APICAL INDUSTRIES, INC.	ENGINEERING CHANGE NOTICE NO. 03700				SHEET 1 OF 1	
	DWG NO. 647.9100	REV: N/C	PREPARED BY B. PETERS	DATE: 11/15/12	EFFECT ON DWG <input type="checkbox"/> INC. <input checked="" type="checkbox"/> UNINC.	
	DWG TITLE: THRUSERT					
	APPROVED BY: ENGR <i>[Signature]</i>	MFG <i>[Signature]</i>	QC <i>[Signature]</i>	EFF: NEXT ORDER		
TRANSACTION CODES (TC): A-ADD C-CREATE R-REVISE D-DELETE	REASON: ADDED ALTERNATE MATERIAL.				ECR: D-12-007

APICAL INDUSTRIES, INC.	ENGINEERING CHANGE NOTIC NO. 03294				SHEET 1 OF 1	
	DWG NO. 647.9100	REV: N/C	PREPARED BY A. QUAN	DATE: 12/07/11	EFFECT ON DWG <input type="checkbox"/> INC. <input checked="" type="checkbox"/> UNINC.	
	DWG TITLE: THRUSERTS					
APPROVED BY: ENGR <i>[Signature]</i>		MFG <i>[Signature]</i>	<i>[Signature]</i>	EFF: CURRENT ORDER		
TRANSACTION CODES (TC): A-ADD C-CREATE R-REVISE D-DELETE		REASON: REVISED MATERIAL DUE TO AVAILABILITY ISSUES

THRUSERT

647.9100

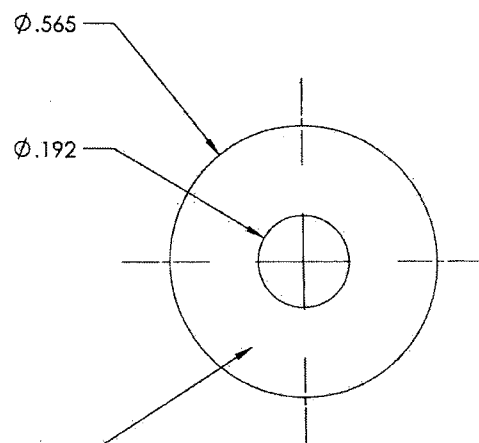
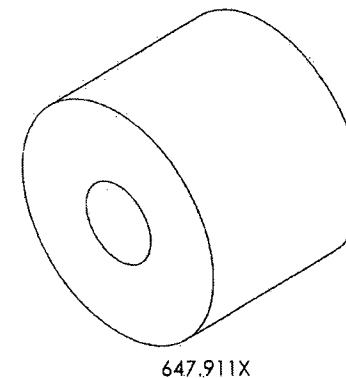
**SHEET 1, ZONE A2 IS:**

**SHEET 1, NOTES IS:**

1. PRIMARY MATERIAL: 303 SS IAW AMS 5640  
ALTERNATE MATERIAL: AISI 303 SS PER ASTM A582

1. MATERIAL: 303 SS IAW AMS 5640.
2. FINISH: NONE.
3. DEBURR AND BREAK ALL SHARP EDGES.
4. IDENTIFY IAW MPP-120. LASER ETCH P/N AND REVISION 12 PT. CENTURY GOTHIC.
